#### HISTORIC AND DESIGN REVIEW COMMISSION

June 15, 2016 Agenda Item No: 3

HDRC CASE NO: 2016-200 COMMON NAME: Amtrak

APPLICANT: Flores Engineers, Inc OWNER: SSG Hotels, LLC TYPE OF WORK: Additional parking

> SHEET C100

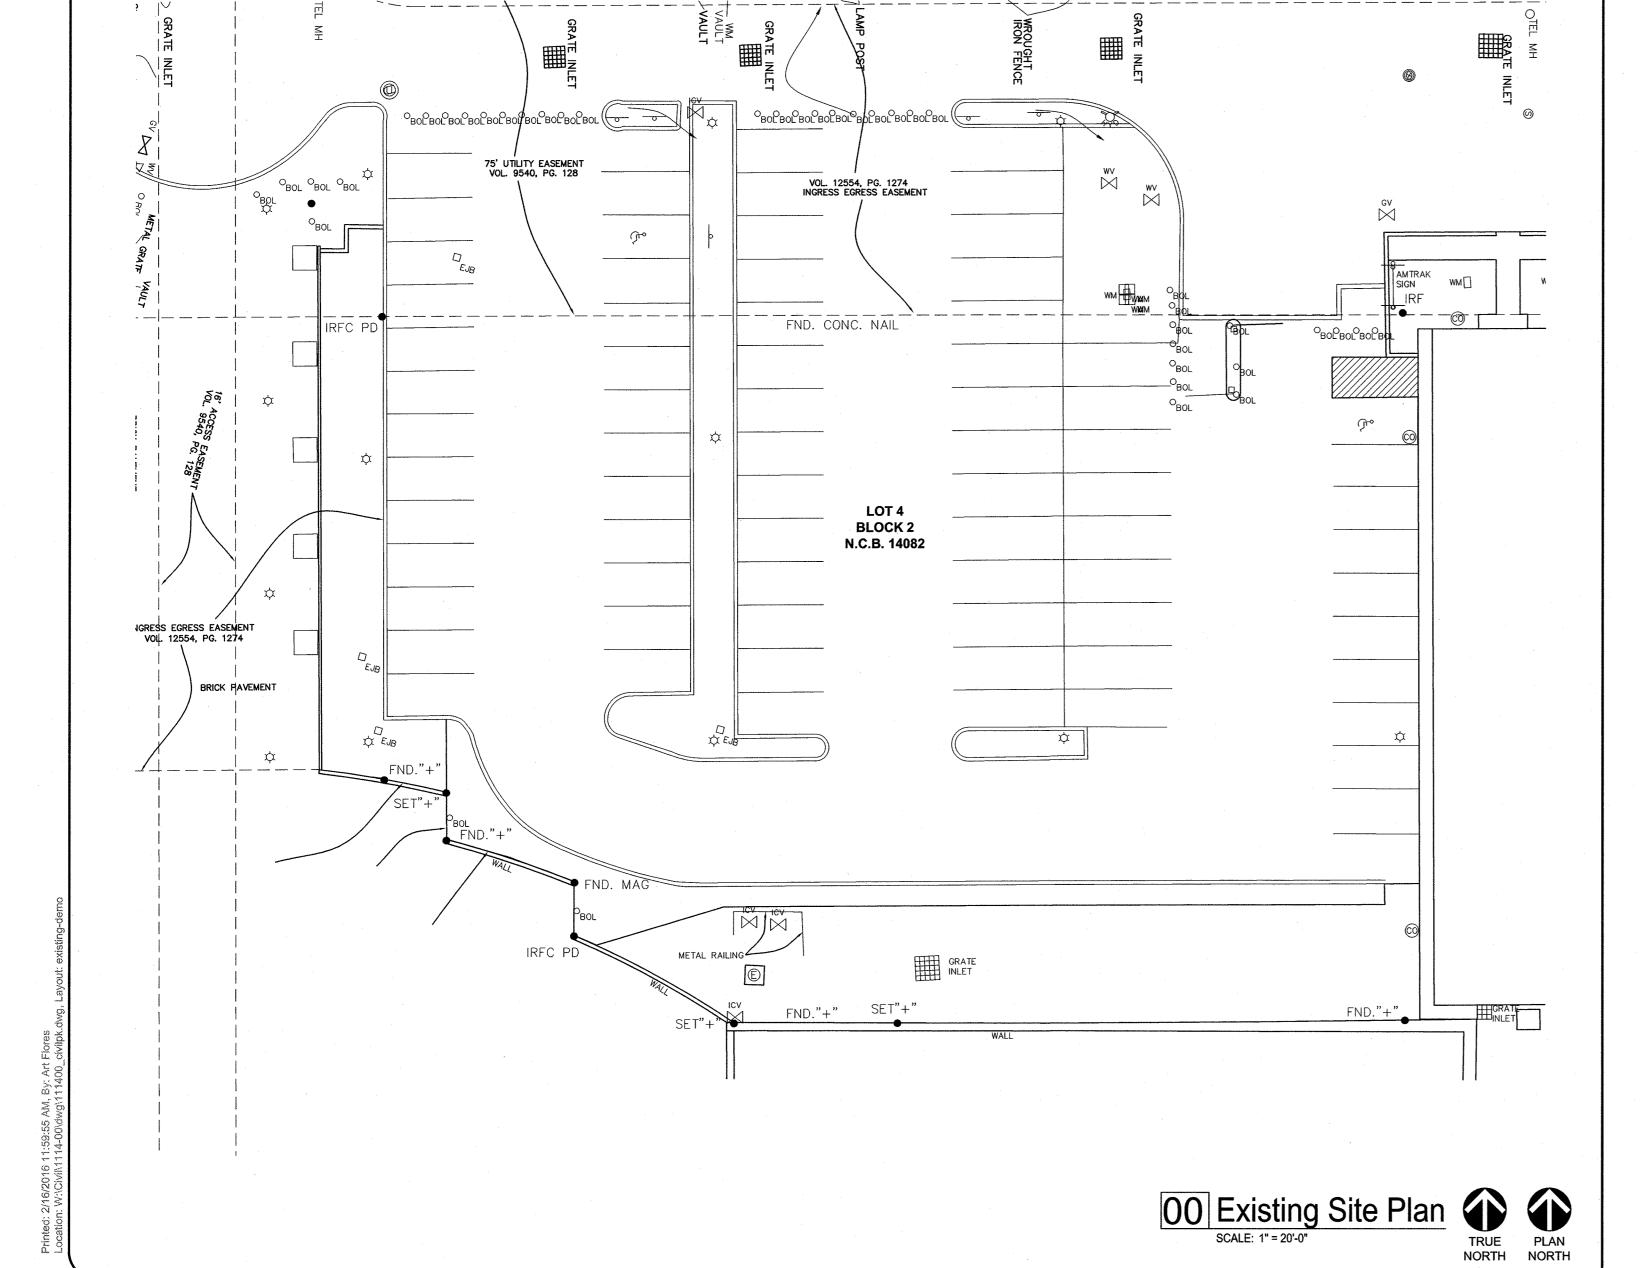
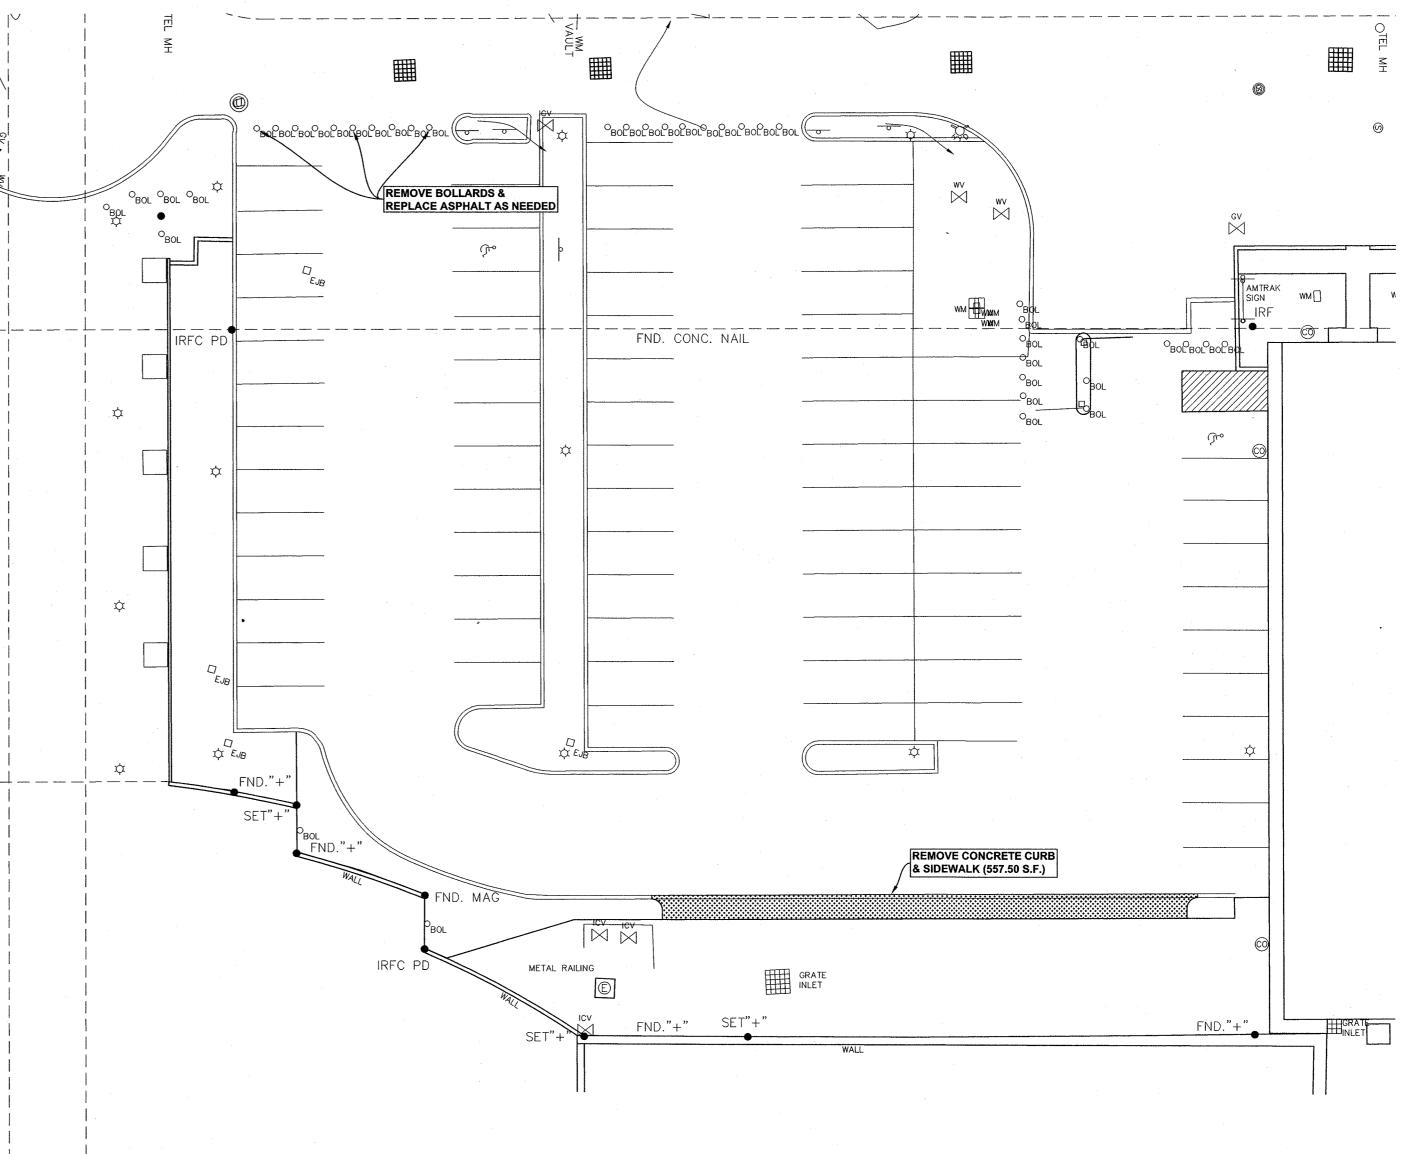
- a. The applicant is proposing to add twelve additional parking spaces on the south of the existing parking lot, extending the lot with paving to match existing. The proposed spaces will require the removal of a curb, grass area and sidewalk. The current area has seven small trees and the applicant is proposing to remove two hackberry trees.
- b. The parking spaces extend toward an existing concrete wall, separating the parking lot from the lowered bus terminal. The proposal is consistent with the Guidelines for Site Elements 7.A. as the additional 12 spaces are screened by a wall and hidden from the public right of way.

Staff recommends approval as submitted based on findings a and b.
